## JOINT REGIONAL PLANNING PANEL (Sydney West)

JRPP No	2014SYW112
DA Number	DA0289/14
Local Government Area	Ku-ring-gai
Proposed Development	Demolish existing & construct new church hall & rectory
Street Address	3A Hill Street Roseville and 1 Bancroft Avenue, Roseville
Lot & DP	Lots 2, 3 and 4 in DP 1046733
Applicant	St Andrews Anglican Church Roseville
Owner	Anglican Church Property Trust Diocese of Sydney
Number of Submissions	Original proposal: 20 in support, 5 objections Amended proposal: 3 in support, 2 objections
Regional Development Criteria (Schedule 4A of the Act)	The proposed place of public worship has a CIV of over \$5 million and falls into the category of 'private infrastructure and community facility'
List of All Relevant s79C(1)(a) Matters	SEPP 55 – Remediation of Land SEPP (Sydney Harbour Catchment) 2005 SEPP (Infrastructure) 2007 Ku-ring-gai LEP (Local Centres) 2012 Local Centres DCP Development Contributions Plan 2010
List all documents submitted with this report for the panel's consideration	Attachment A – Pre DA Report Attachment B – Letter to applicant Attachment C – Heritage Consultant comments Attachment D – Clause 4.6 variation Attachment E – Plans and ele

**Figure 2 - Hill Street elevation showing height of proposed building and existing residential flat building. The 11.5m height limit is shown as a dashed line.**

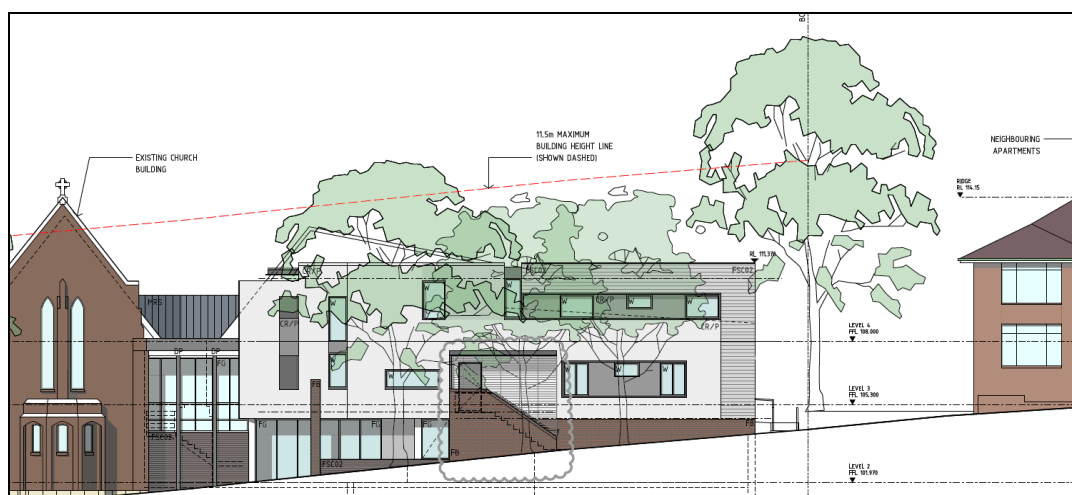
The applicant's argument that a development which retained the church and proposed a larger church hall would result in greater impacts on the apartment building at 3 Hill Street are overstated. The proposed building form envisaged by the applicant appears to be a 3 storey high structure built to the boundaries. The proposed floor space ratio is 0.76:1 and the maximum floor space ratio is 0.85:1. To achieve the maximum floor space ratio the gross floor area would only need to be increased by 188m<sup>2</sup>. In theory this increase could be achieved by filling in part of the void areas and making no changes to the building envelope. Alternatively, if changes to the building envelope were required it is unlikely that achieving an additional 188m<sup>2</sup> of floor area (an 11.8% increase in a 1580m<sup>2</sup> building) would require an additional storey with the same footprint as the storey below. If the height of the building at 3A Hill Street was increased the additional shadowing impact on the apartments at the north-western corner of the building would be offset by providing an open outlook to the apartments located in north-eastern corner of the building and the common area located at the rear of the residential flat building. If adequate setbacks from the southern boundary were provided it is likely that an additional storey on the Hill Street elevation would have minimal impact on solar access to the apartments at 3 Hill Street.

**Figure 4 - The existing landscape corridor at the rear of 1-17 Bancroft Avenue contains trees and ancillary structures**

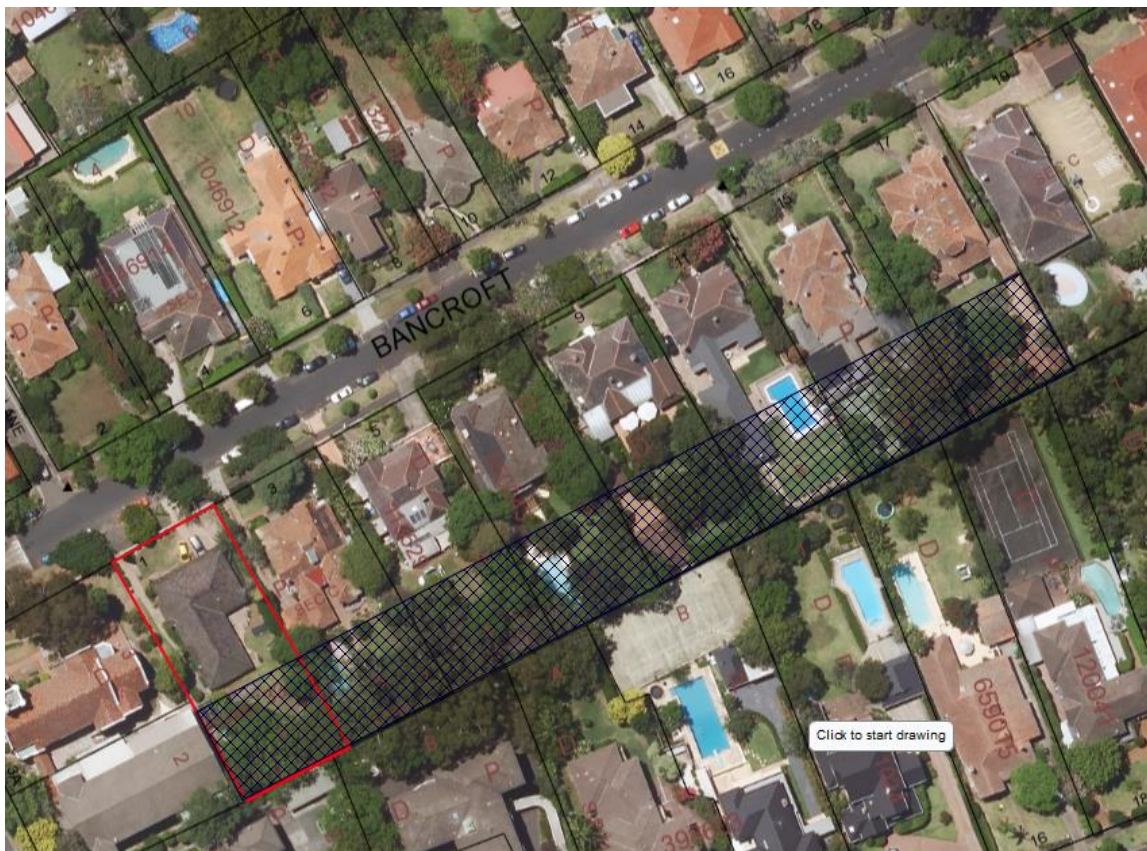
The photomontage is not an accurate representation of the development as it shows tree canopies to the southern and eastern sides of proposed building. The development seeks to remove 7 of the 8 trees located in the backyard of 1 Bancroft Avenue. The retention of a single Brushbox tree in the south-western corner of the site will not achieve the landscape setting described in the photomontage. Figure 4 shows the existing landscaped corridor at the rear of Nos. 1-17 Bancroft Avenue.
